Customer Notification

Customer Notification: 51-1452
DTNA: FL917A

March 2022
FL917A
NHTSA #21V-00H

Subject: FCCC Chassis Rear PDM

Fig. 1, Jumper Harness Installation

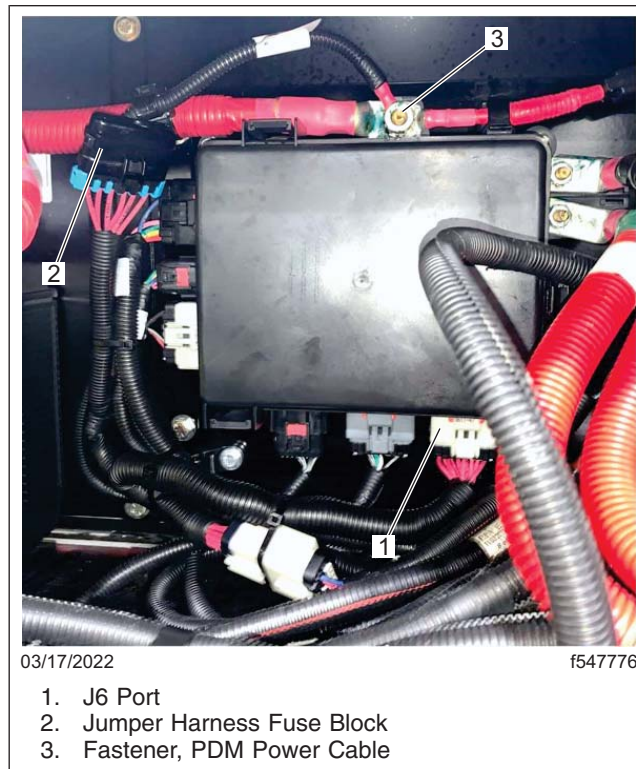
Jumper Harness Installation

Refer to [Fig. 1](#) for this procedure.

1. Inspect the base label (Form WAR259) for a campaign completion sticker for FL917 (Form WAR260). If a sticker is present for FL917, no work is needed. If there is no sticker, proceed with the steps below.
2. Park the vehicle on a level surface, shut down the engine, and set the parking brake. Chock the tires.
3. Disconnect the batteries.
4. Disconnect the 14-pin chassis harness connector from the power distribution module (PDM) J6 port.
5. Connect the chassis harness female connector to the A66-29948-001 jumper harness male connector. Make sure the connector is fully seated and the red tab is locked.
6. Connect the female connector of the A66-29948-001 jumper harness to the PDM J6 port. Make sure the connector is fully seated and the red tab is locked.
7. Remove the fastener that secures the power cable to the PDM power supply post.

8. Position the ring terminal of the jumper harness on the PDM power supply post, then install the fastener. Tighten the fastener 16 lbf·ft (22 N·m).
9. Using a tie strap, secure the jumper harness fuse block to the nearest harness.

10. Route the jumper harness along other harnesses, then secure it with tie straps.
11. Connect the batteries.
12. Test the function of all the rear lights.
13. Clean a spot on the base label (Form WAR259) and attach a campaign completion sticker for FL917 (Form WAR260), indicating this work has been completed.
